SERVICE PROCEDURE

16513

SUBJECT: SAFETY RECALL
Battery Box Latch on certain 2017 model year 9900i, LoneStar®, ProStar®, and TranStar® model trucks built 13 June 2016 thru 08 December 2016 with feature code 08WBW (Battery Jump Start Stud)

Figure 1. Battery Box Cover Latch

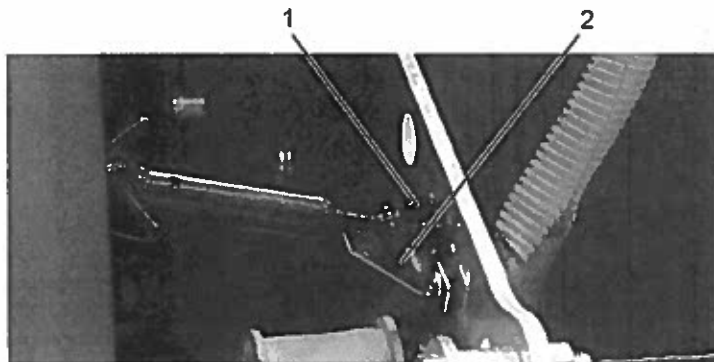
The metallic battery box cover latch, when unlatched from its anchor may articulate and potentially contact the battery jump start stud. If the protective cover of the jump start stud is not in place, such contact may result in an electrical short to ground. An electrical short to ground may cause a vehicle fire resulting in property damage or personal injury.

6. Remove lower latch fasteners (Figure 1, Item 2) from battery box.
